<b>Well Name:</b> POKER LAKE UNIT 20 DTD	<b>Well Location:</b> T24S / R30E / SEC 20 / NENW / 32.207741 / -103.906243	<b>County or Parish/State:</b> EDDY / NM
<b>Well Number:</b> 218H	<b>Type of Well:</b> CONVENTIONAL GAS WELL	<b>Allottee or Tribe Name:</b>
<b>Lease Number:</b> NMNM02860	<b>Unit or CA Name:</b> POKER LAKE UNIT	<b>Unit or CA Number:</b> NMNM71016X
<b>US Well Number:</b>	<b>Operator:</b> XTO PERMIAN OPERATING LLC

**Type of Submission:** Notice of Intent      **Type of Action:** APD Change

**Procedure Description:** XTO Permian Operating, LLC. respectfully requests approval to make changes to the approved APD as follows: SHL, FTP, LTP, BHL and drilling plan. Casing sizes are not changing but casing and cement program are being updated. FROM: TO: SHL: 965' FNL & 1840' FWL OF SECTION 20-T24S-R30E 815' FNL & 2330' FWL OF SECTION 20-T24S-R30E FTP: 100' FSL & 990' FWL OF SECTION 17-T24S-R30E 100' FNL & 1735' FWL OF SECTION 20-T24S-R30E LTP: 330' FNL & 990' FWL OF SECTION 32-T23S-R30E 2341' FNL & 1735' FWL OF SECTION 5-T25S-R30E BHL: 200' FNL & 990' FWL OF SECTION 32-T23S-R30E 2441' FNL & 1735' FWL OF SECTION 5-T25S-R30E The proposed total depth is changing from 33070' MD;

*Note: Picture below highlights BOP components that will be tested during batch operations*

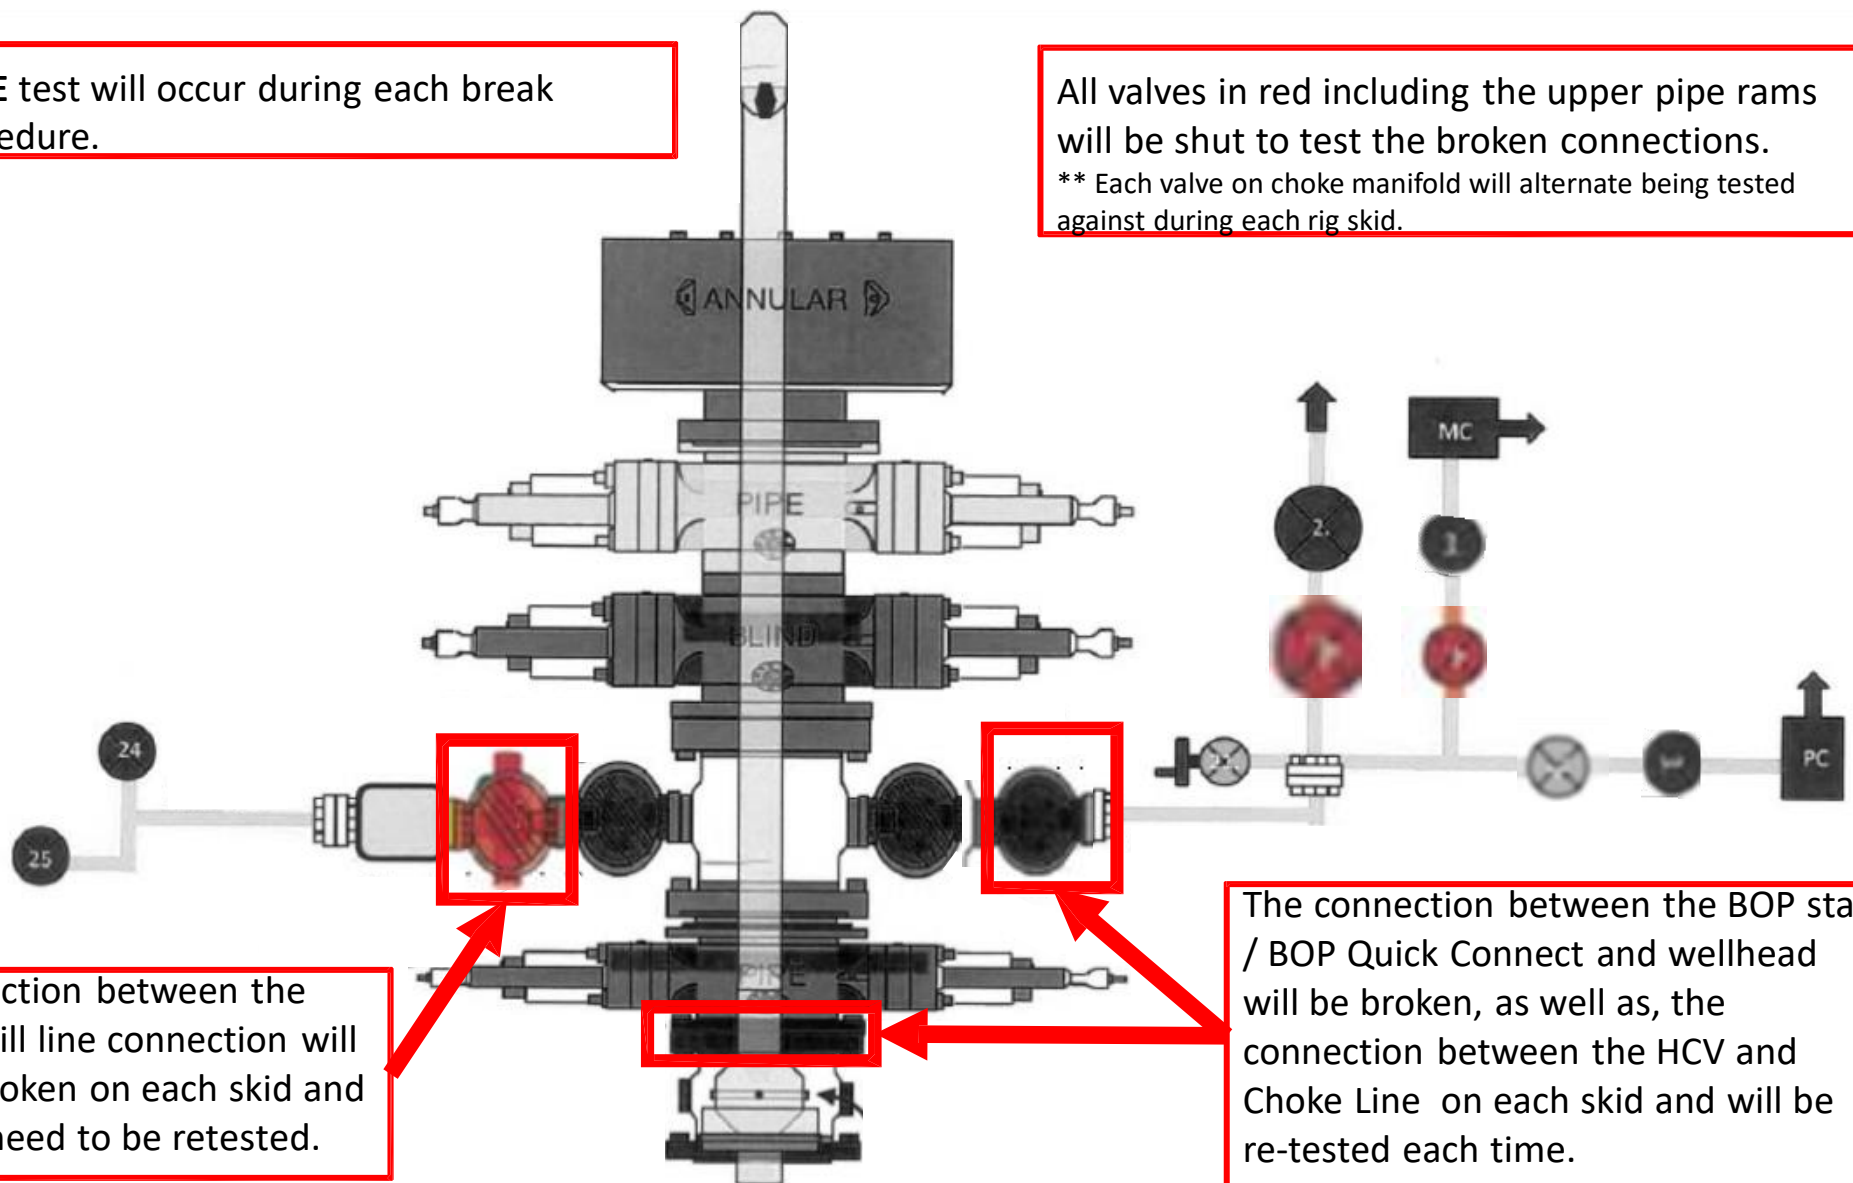
All valves in red including the upper pipe rams will be shut to test the broken connections.  
\*\* Each valve on choke manifold will alternate being tested against during each rig skid.

The connection between the HCV and kill line connection will **NOT** be broken on each skid and does not need to be retested.

The connection between the BOP stack / BOP Quick Connect and wellhead will be broken, as well as, the connection between the HCV and Choke Line on each skid and will be re-tested each time.
